Norfolk Southern Corporation Coordination

Brush College Road Improvement Study
Stakeholder Contact Log

NEW BRUSH COLLEGE ROAD BRIDGE
OVER NS
CONCEPT PLANS
DECATUR, ILLINOIS

GENERAL PLAN
FAU 7448 (BRUSH COLLEGE ROAD) OVER FARIES PARKWAY
SECTION
CITY OF DECATUR
MACON COUNTY
STATION 61+27.39
STRUCTURE NO.

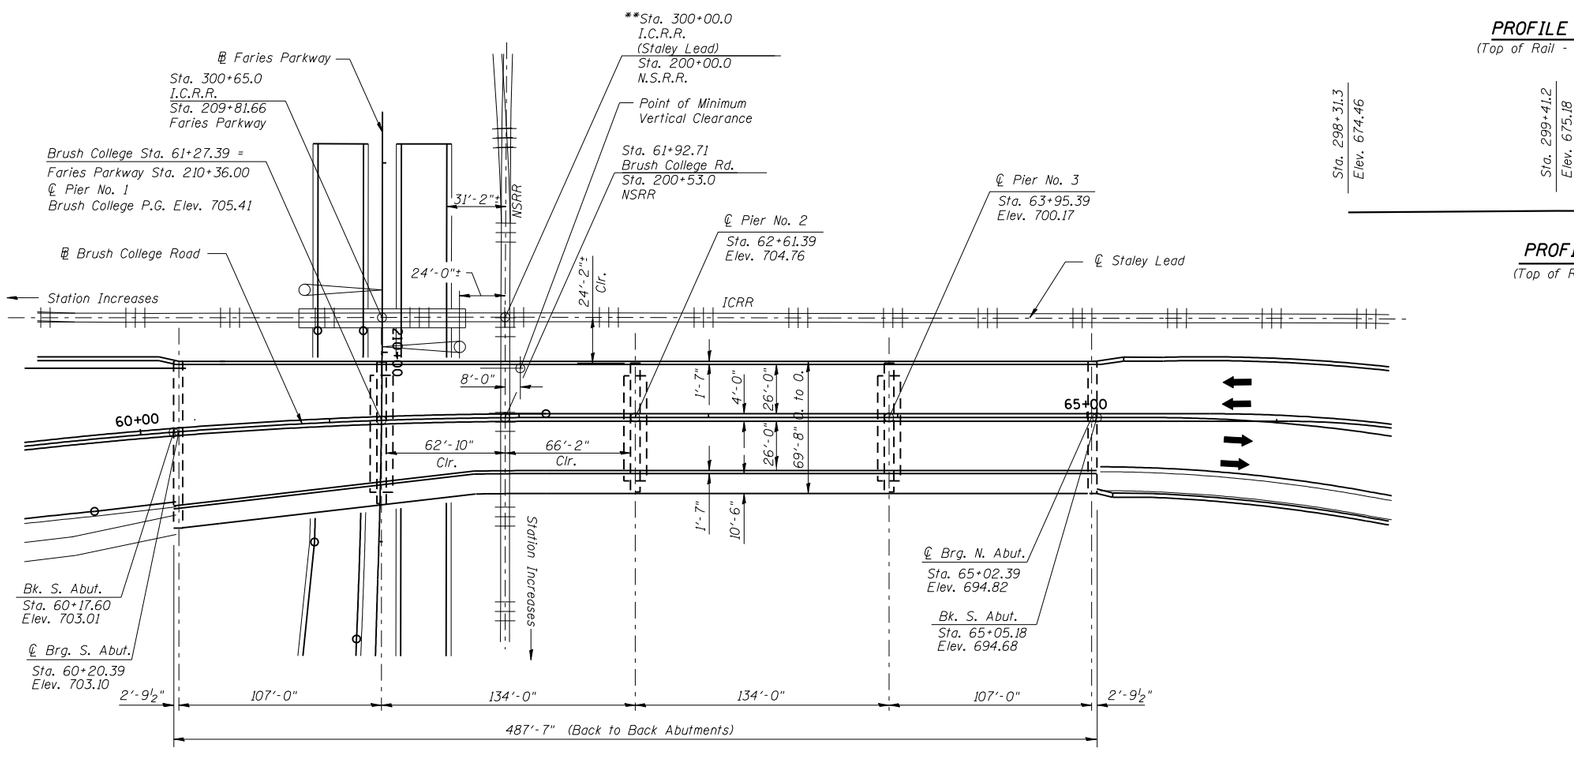
9	Exhibit J	Brush College Road over NS and Faries Parkway TS&L indicates: • Minimum vertical clearance is 24 ft. 6 in. above top of rail • Minimum horizontal clearance to be provided from face of pier to centerline of the nearest track is 62 ft. 10 in.	Closed
10	Exhibit J	Distance from edge of pavement to centerline of track not shown. Please provide. Proposed grade crossing warning devices for CN track to be located adjacent to NS track. Please provide distance from centerline of track to signal.	Open

The distance from the edge of pavement to the centerline of track and the distance from the centerline of track to the crossing signal have been added to the attached General Plan of the Type, Size, & Location drawing for the proposed overpass at Faries Parkway.
